TRANS/WP.29/2001/30
12 April 2001

PROPOSAL FOR DRAFT SUPPLEMENT 2 TO THE 05 SERIES
OF AMENDMENTS TO REGULATION No. 83

(Emissions of M₁ and N₁ categories of vehicles)

Transmitted by the Working Party on Pollution and Energy (GRPE)

Figure 8/1: Parameters measured during emissions test during and between cycles where regeneration occurs (schematic example, the emissions during 'D' may increase or decrease)

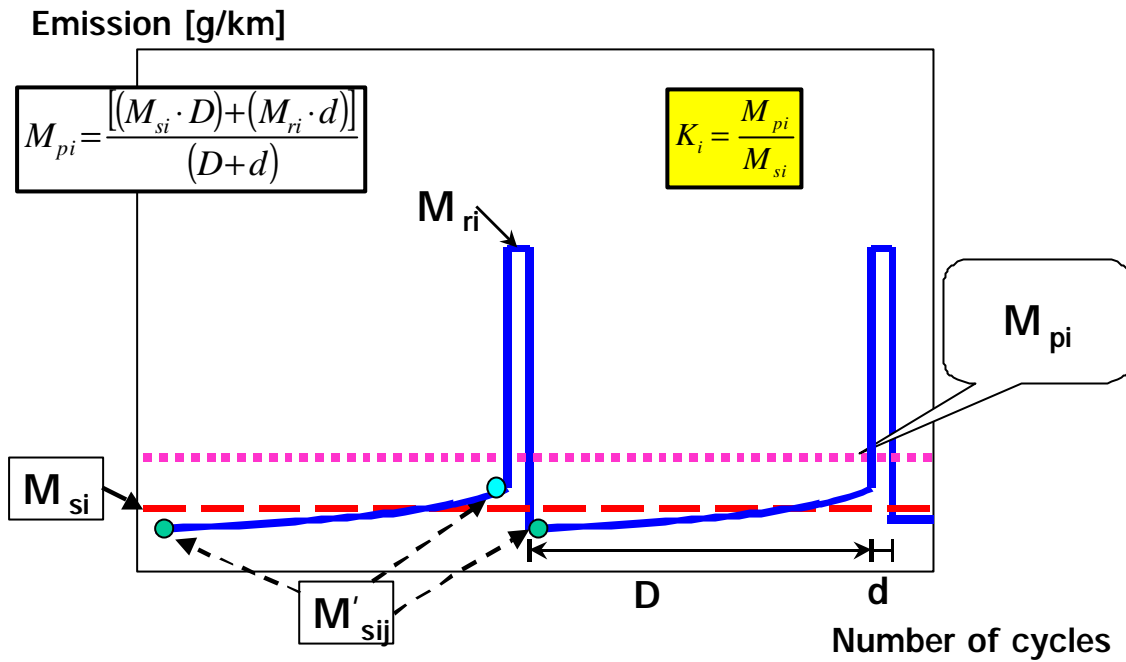
3.2.6. The emission values during regeneration (M_{ri}) shall be calculated according to annex 4, paragraph 8. The number of operating cycles (d) measured for complete regeneration shall be recorded.

$$M_{si} = \frac{\sum_{j=1}^n M'_{sij}}{n} \quad n \geq 2 ; \quad M_{ri} = \frac{\sum_{j=1}^d M'_{rij}}{d}$$

$$M_{pi} = \left\{ \frac{M_{si} * D + M_{ri} * d}{D + d} \right\}$$

For exemplary illustration of measurement parameters see figure 8/1.
